REPORT DOCUMENTATION PAGE		READ INSTRUCTIONS BEFORE COMPLETING FORM
1. REPORT NUMBER	2. GOVT ACCESSION NO.	3. RECIPIENT'S CATALOG NUMBER
4. TITLE (and Subtitle) A PRELIMINARY HUMAN ENGINEERING EVALUATION OF HYPERBARIC CONTROL SYSTEMS.		5. TYPE OF REPORT & PERIOD COVERED Medical Research Progress Report.

**A PRELIMINARY HUMAN ENGINEERING EVALUATION
OF HYPERBARIC CONTROL SYSTEMS**

The information to be reported emanates from a preliminary evaluation dealing with human factors design adequacy of hyperbaric control/displays developed for the hyperbaric research facility. Although the control-panel designs had been approved and fabrication was underway, a preliminary review of the engineering diagrams for the control panel revealed that the existing designs might contribute significantly to decrements in overall system performance: a thorough human factors engineering analysis appeared to be required. The scope of this report is limited to an analysis of the instrumentation/man interface.

Fig. 3. Panel #3007872 was rated unsatisfactory in regard to the specification of component accessibility. (The human operator is 5 ft 10 inches tall.)

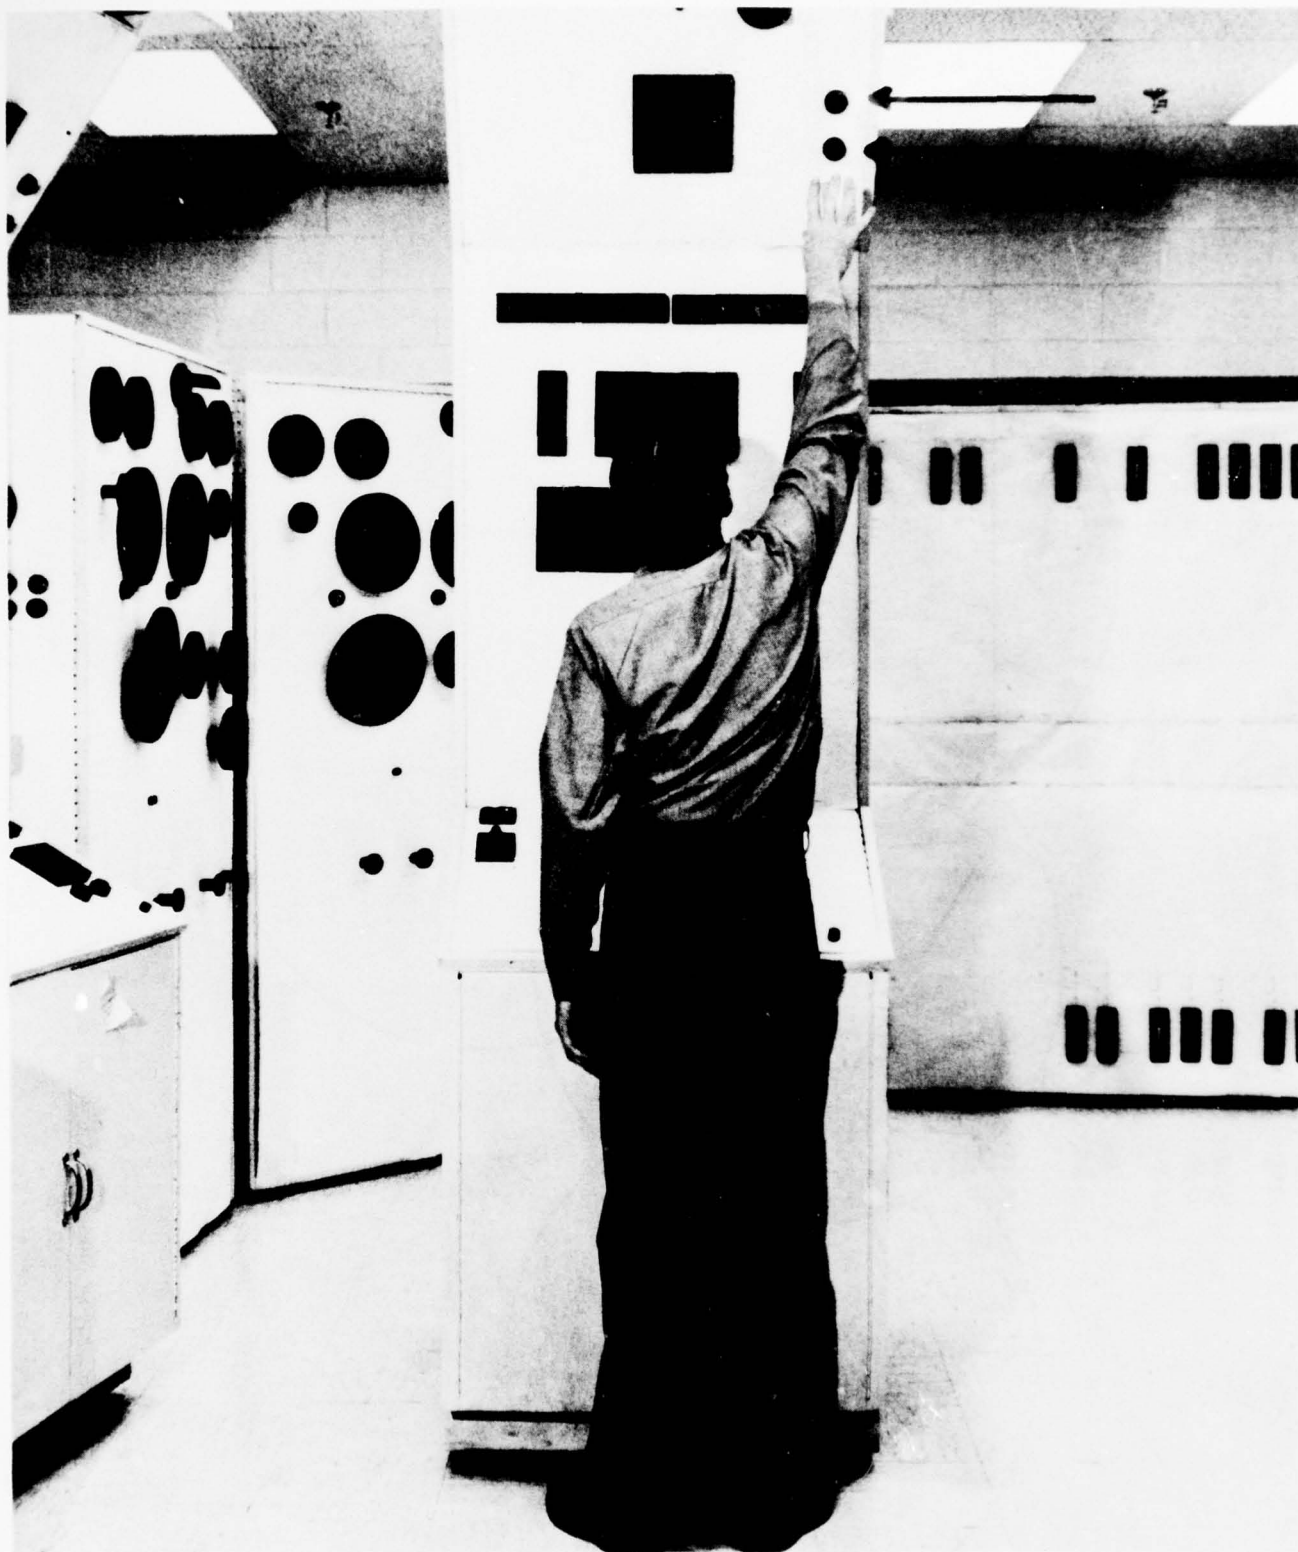
<u>Component Name</u>	<u>Panel</u>	<u>Drawing</u>
Annunciator test button	MRC OP ¹	3007870
Annunciator acknowledge button	MRC QP	3007870
Elapse-time clock	MRCC ²	3007872
Annunciator test button	MRCC	3007871
Annunciator acknowledge button	MRCC	3007871

Based on known diver anthropometrics (Beatty and Berghage, 1972), we determined that only Navy divers from the 85th through 99th percentile-height could reach these components without leaning against the console, standing on their toes, or making gross, uncoordinated movements from the standing position. A sample of divers³ representing the 5th through 35% percentile-heights of U.S. Navy divers³ could reach these components only if they were able to stand on an object 3 to 5 inches above the deck. It is recommended that these components be moved at least 6 inches downward toward the lower console.

Figures 3 and 4 present an illustrative representation of the problem. The arrows are pointing to the five components listed above.

Fig. 5. Local panel #3007874 shows the relative position of the sanitary drain controls. This side panel should be swung toward the front so that all controls and indicators are in the monitor's line of sight.

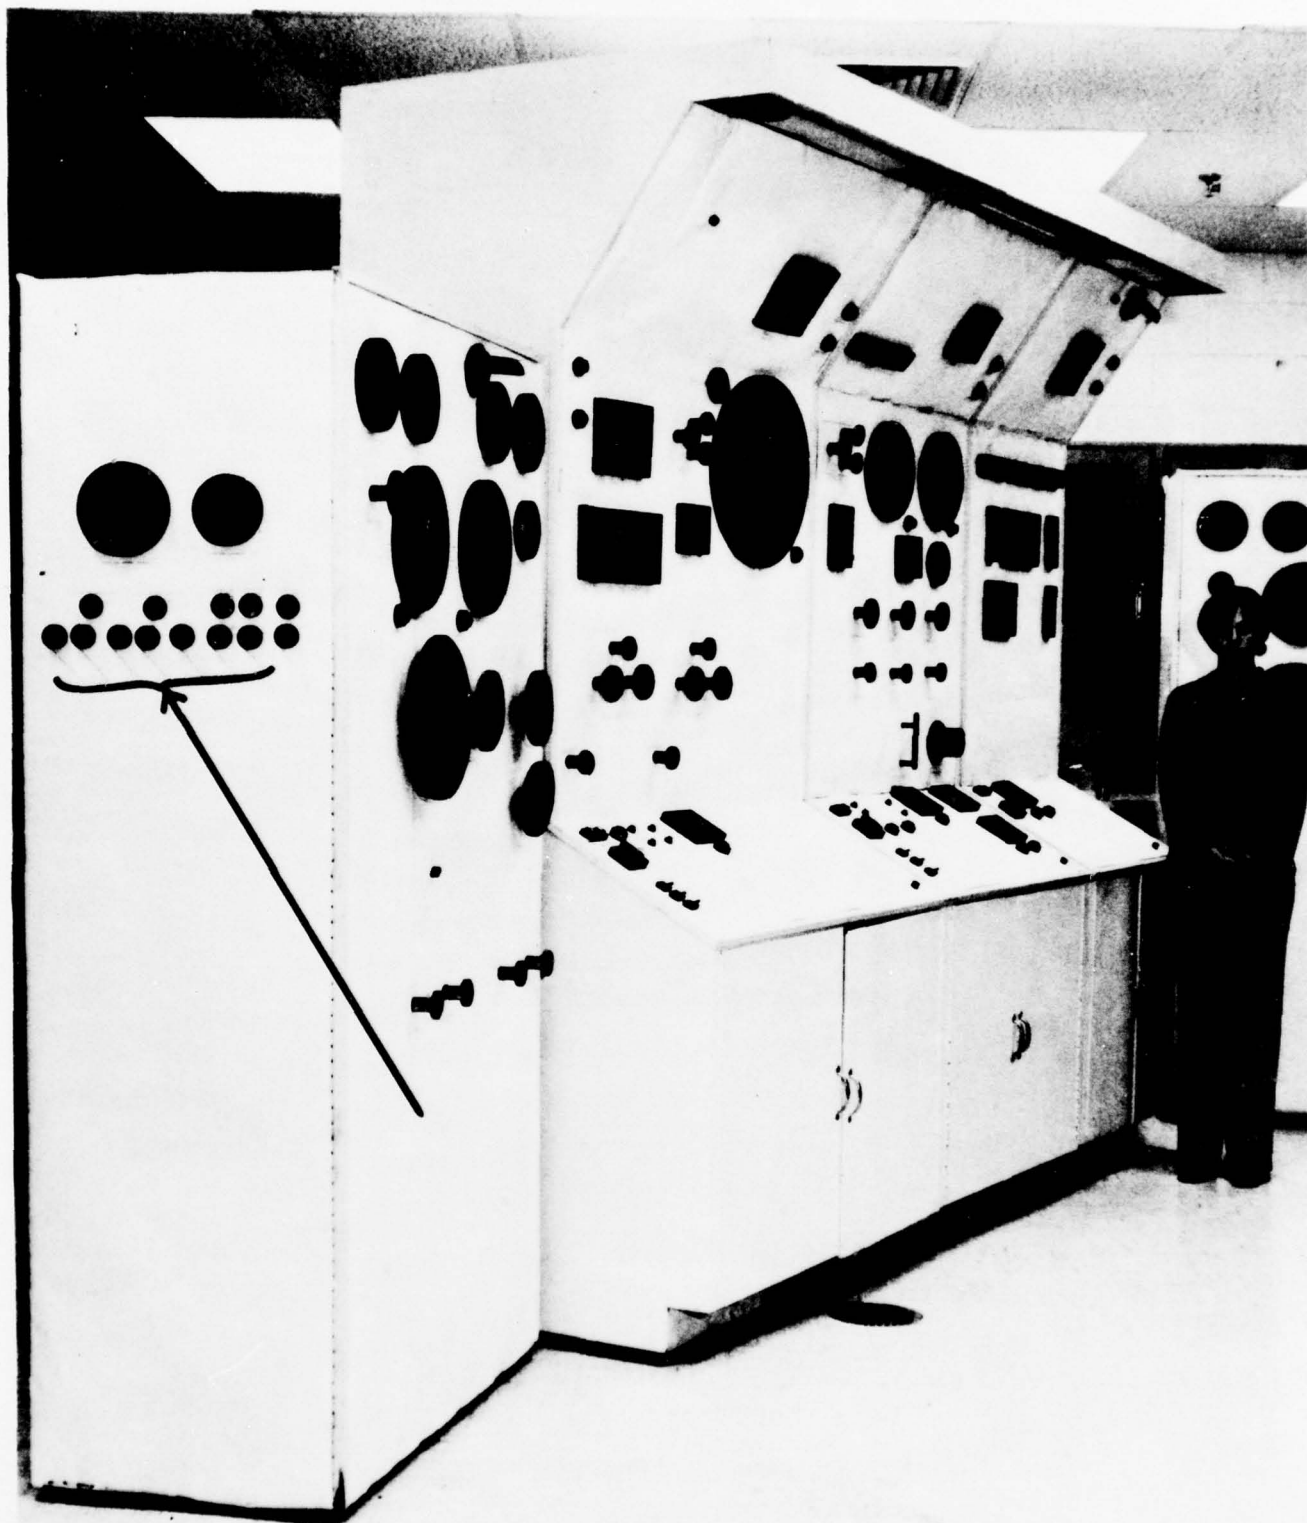
Direct observation revealed that components located on the left side of the local panel in Fig. 5 were accessible only if an operator/monitor walked from the front of the console to the left side of the panel. These components, all relating to sanitary-tank control, are listed: pressure indicator, differential pressure, isolation valve, pressure button, vent, flush, and drain.

When viewing the front of the same local panel (Fig. 5), these components cannot be seen. To manipulate the components, the operator must physically move around to the side, leaving the front of the local panel unmonitored.

It is recommended that the components listed above be displayed on the front of the panel. This could be accomplished by swinging the side panel out and around so that it faces the operator.

Fig. 6. Control panel #3007874 (left) has its control meter shut-off valves inconsistently placed in relation to control panel #3007871 (right). Note arrows.

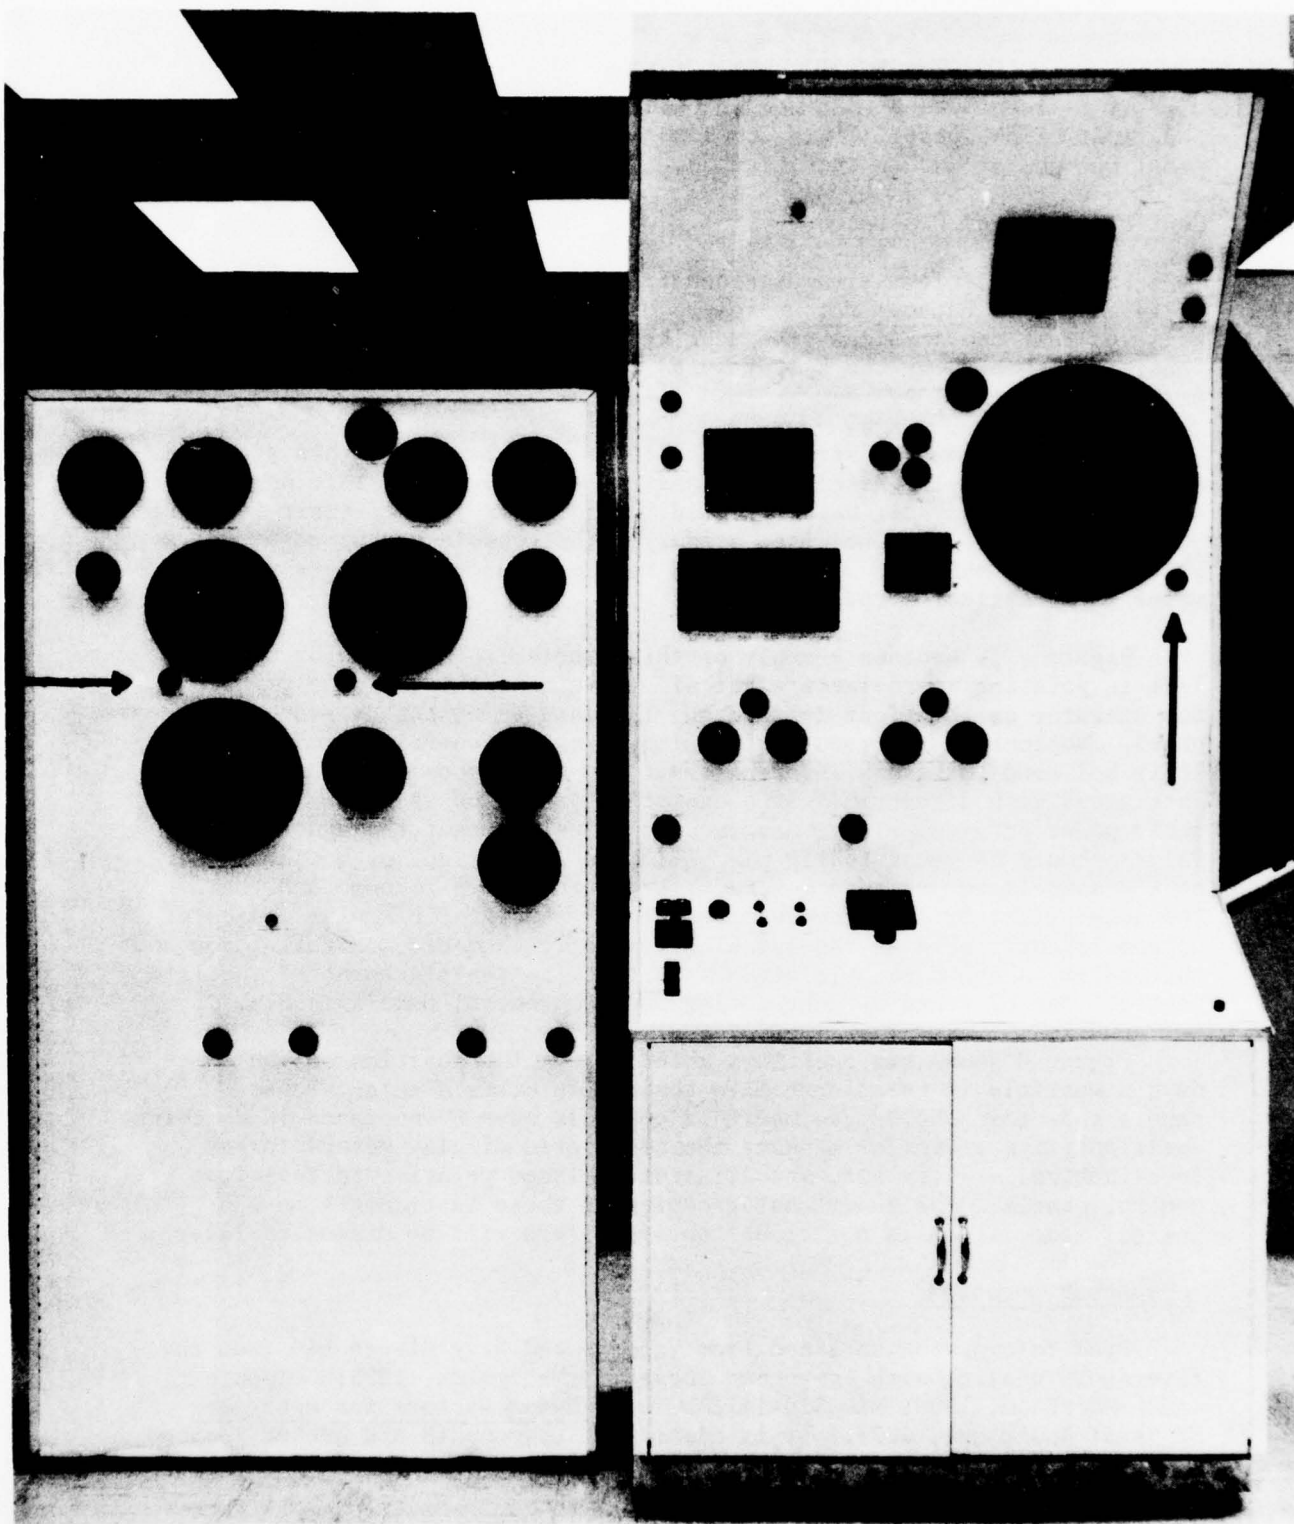
Figure 6 is an illustrative example of a violation of this standard. Note that the display panel of the control console on the left has two pressure meter shut-off valves placed to the lower left of their respective meters on this local panel (see arrows). The console on the right has a pressure meter shut-off valve located to the lower right of its respective meter (see vertical arrow).

Fig. 7. Control panel #3007874 (right) has its control meter shut-off valves inconsistently placed in relation to control panel #3007872 (left). The men in the picture are pointing to these controls.

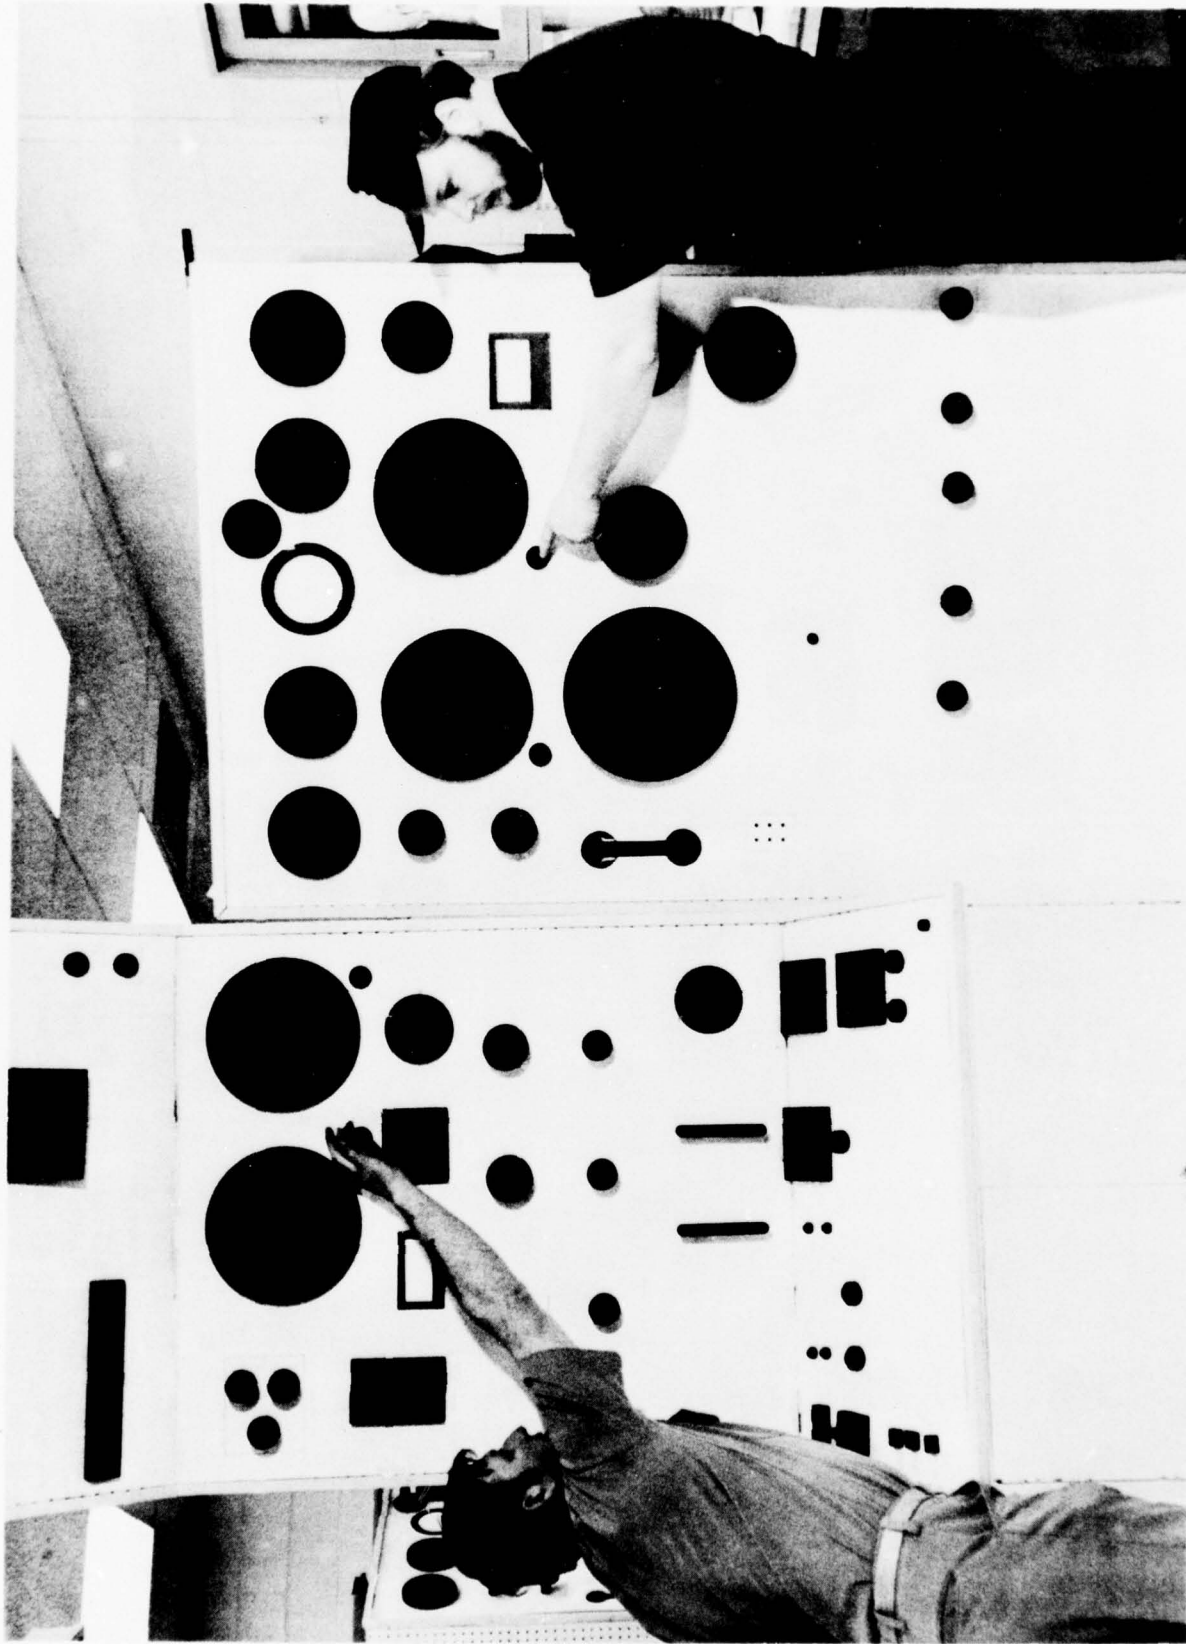
Figure 7 is another example of this problem. The operator on the left is pointing to the meter-shut off valve on one local panel, while the operator on the right is touching the same component on another panel. Notice the reversed positioning of these controls (inconsistency). It is believed that such an arrangement may lead to operator confusion. Interviews with divers indicated that this situation is undesirable from their point of view. Their unanimous opinion was that the shut-off valves should be consistently placed to the lower right or bottom center of the associated pressure meters. It is therefore recommended that the lower-right or lower-center area of an associated circular indicator be consistently used as the location for meter shut-off controls throughout the system. Another example of inconsistency in the placement of specific controls can be found by contrasting the two control panels in Fig. 7.

Fig. 8. The oxygen manifold controls are inconsistently placed with respect to control panels #3007872 (left) and #3007870 (right). The men are pointing to these controls (upper arms). Their lower arms are pointing to the display meters.

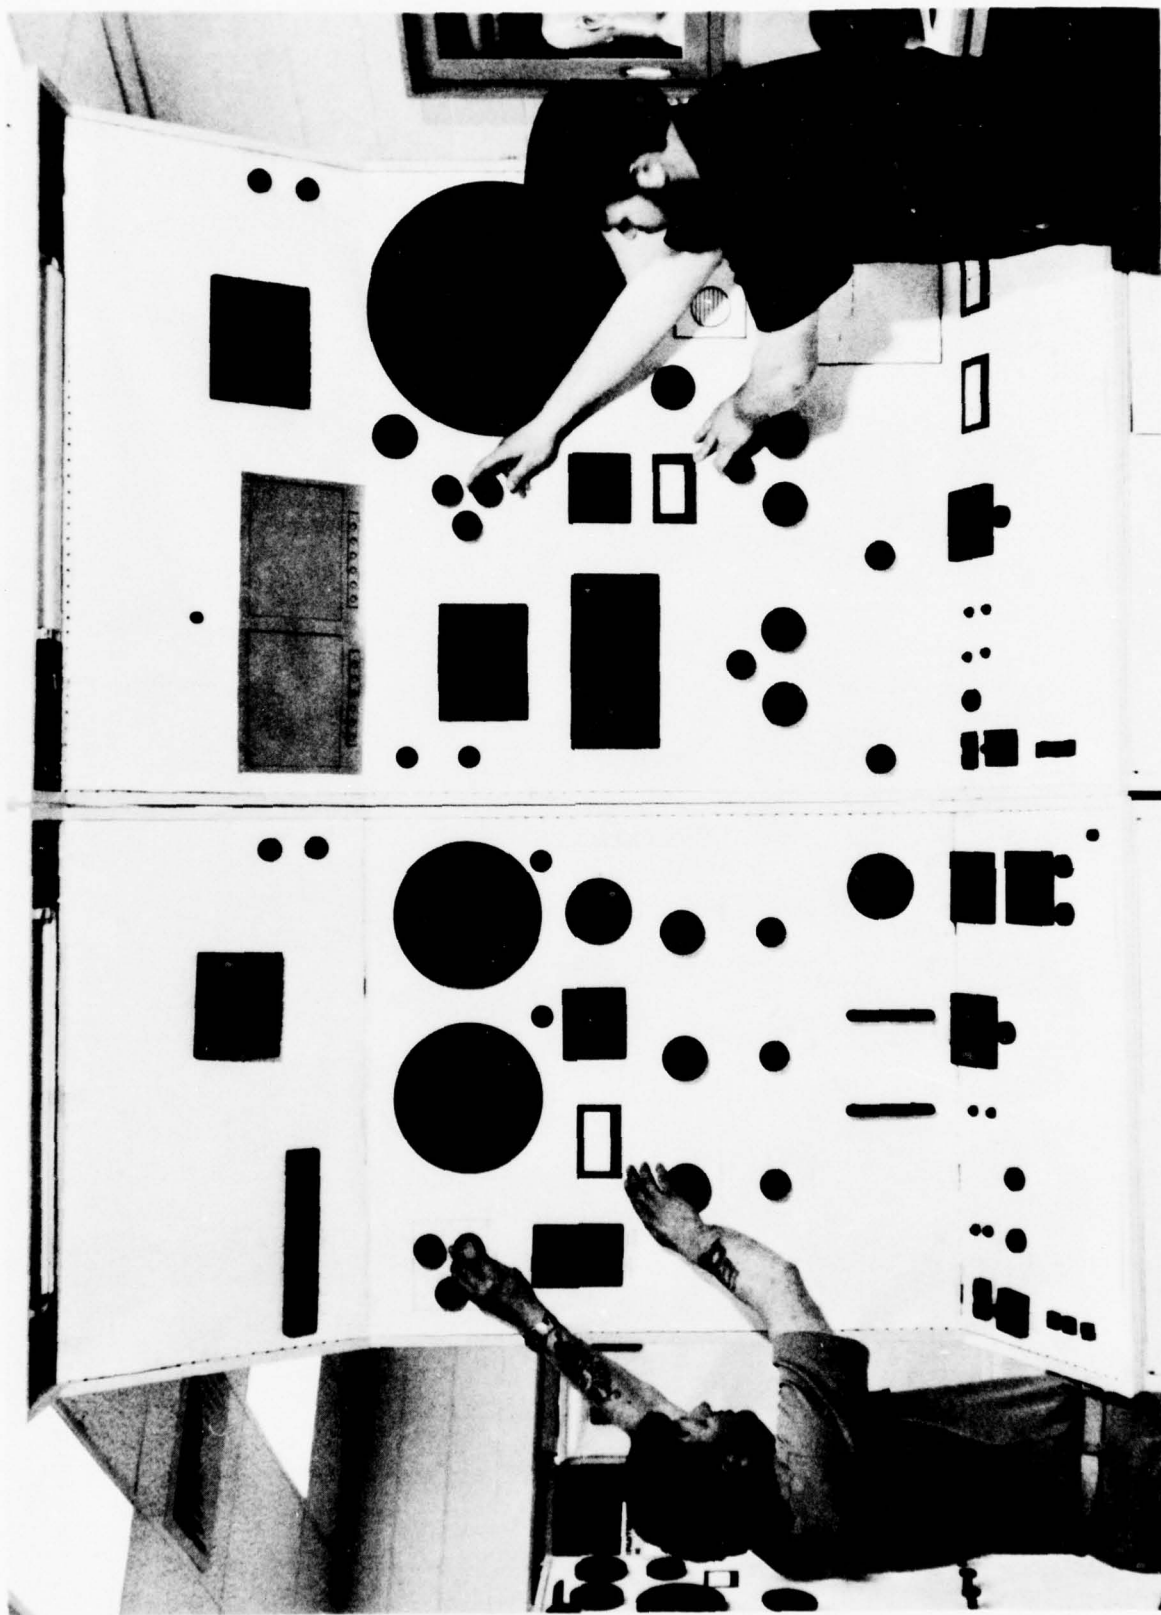
Figure 8 shows two operators pointing out the position of the oxygen manifold in relationship to the oxygen meter display. These panels show that the oxygen manifold controls have been placed in different locations. In a similar manner, the associated display meters (oxygen-level controller) are also inconsistently placed relative to these two control panels. The functional grouping of these instruments in a logical association is not at all obvious. This will be discussed later.

Another example of poor control-display relationships is demonstrated in Fig. 8. Without telling divers the names of blocked-in controls on the panel mock-ups, we asked them to point out the display that they felt to be most likely related to the oxygen manifold. In each instance they picked the FES differential pressure indicator, which of course was incorrect. This demonstration led us to conclude that the oxygen control indicator was not placed properly in relationship to the oxygen manifold controls. We recommend that this situation be changed. To increase the perceived relationship between these instruments, we suggest that they be moved physically closer together in a tight group bounded by strip-lines.
